Groundwater Transfer Review Summary Form

Transfer/PA # T- 14395

Application: T-14395

Applicant Name: Westwood Farms

Figure 1. Estimated time-drawdown with the To-POA pumping at the maximum combined rate of 0.93 CFS

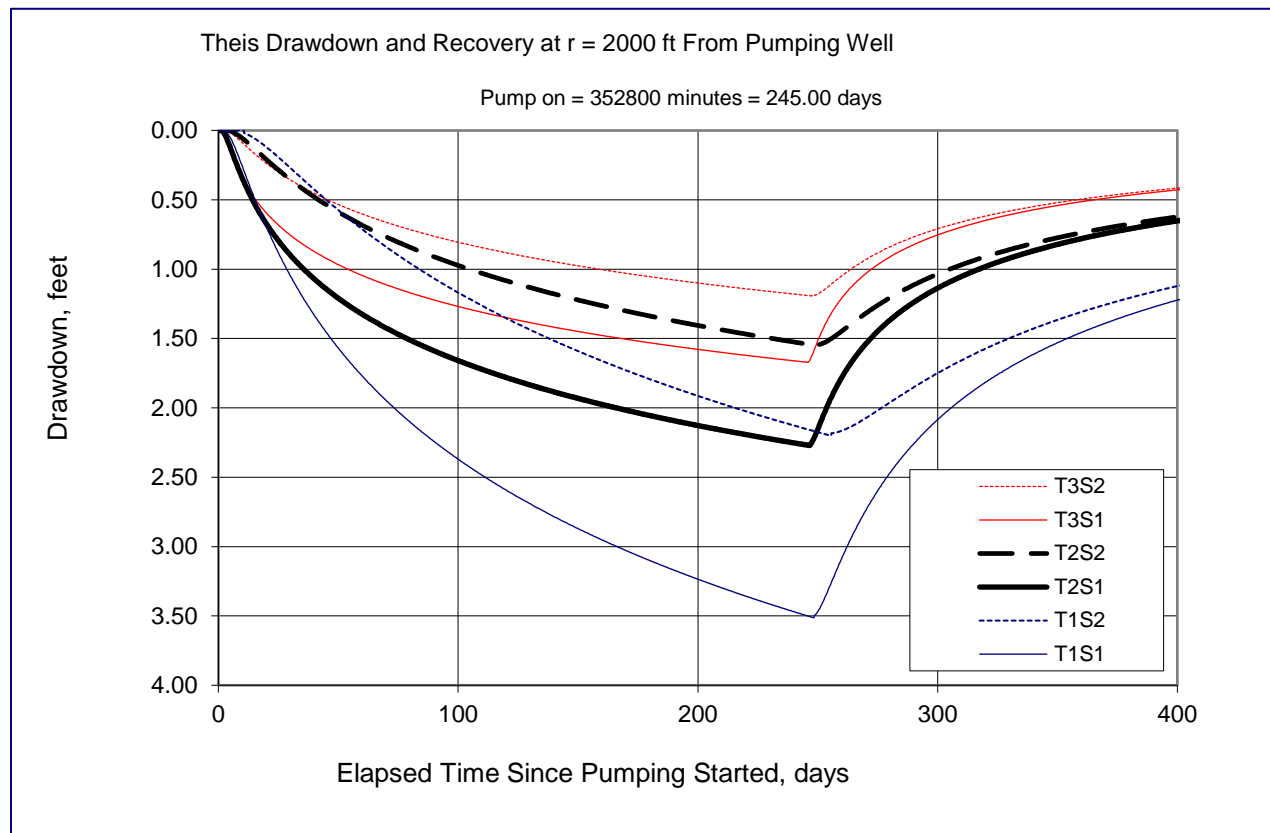
4. a) Will this proposed change, at its maximum allowed rate of use, likely result in an increase in interference with **another ground water right**?
 Yes No Comments: The proposed APOA (MARI 4811) is ~2,000 ft from neighboring well MARI 4814 (POA on GR-459), which is ~1,250 ft closer to MARI 4814 than is the authorized POA (MARI 2932). The closer proximity of the APOA will likely increase interference with MARI 4814.

Rate: (1) 0.93 cfs (maximum combined rate) for the APOA (MARI 4811), (2) 0.17 cfs (remaining rate) for the authorized POA (MARI 2932).

Distance: (1) 2,000 feet from the APOA (MARI 4811) to MARI 4184; (2) 3,750 feet from the authorized POA (MARI 2932) to MARI 4184.

- b) If yes, would this proposed change, at its maximum allowed rate of use, likely result in another groundwater right not receiving the water to which it is legally entitled?
 Yes No If yes, explain: Under the proposed change, the APOA could be pumped at a maximum combined rate of 0.93 cfs (under both Cert 35374 and App G-19414) so long as the authorized POA is not simultaneously pumping more than 0.17 CFS (~75 gpm). The closest water well with a water right not owned by the applicant is MARI 4814, 2,000 feet from the APOA. Modeling with conservative hydraulic parameters indicates drawdown at MARI 4814 would likely be less than 3.85 feet while simultaneously pumping the APOA and the authorized POA at the proposed rates. Given the thickness, high transmissivity, and high storativity of the Willamette Aquifer in this area, the anticipated interference is not likely to cause injury to MARI 4814 or similarly-located neighboring water rights.
